Mask Set Errata for Mask 0M25D

This mask set errata applies to the mask 0M25D for these products:

- MC68HC908AP64
- MC68HC908AP32
- MC68HC908AP16
- MC68HC908AP8

Figure 1. Typical ADC Error Count

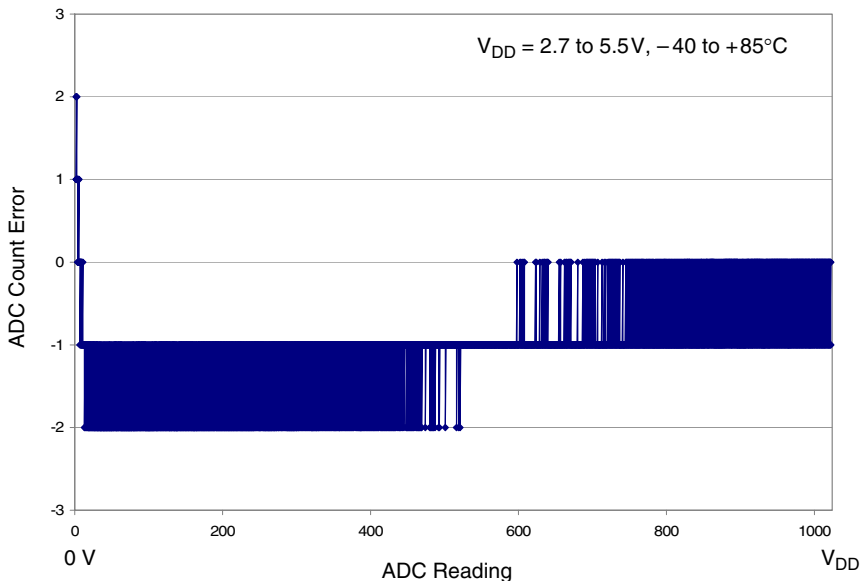
The 10-bit ADC conversion result for 0V input (zero input reading) is \$000, \$001, \$002, or \$003; not the specified \$00 or \$01. With inputs of 5mV and above, the ADC is within the specified accuracy of ± 1.5 LSB (see [Figure 1](#)).
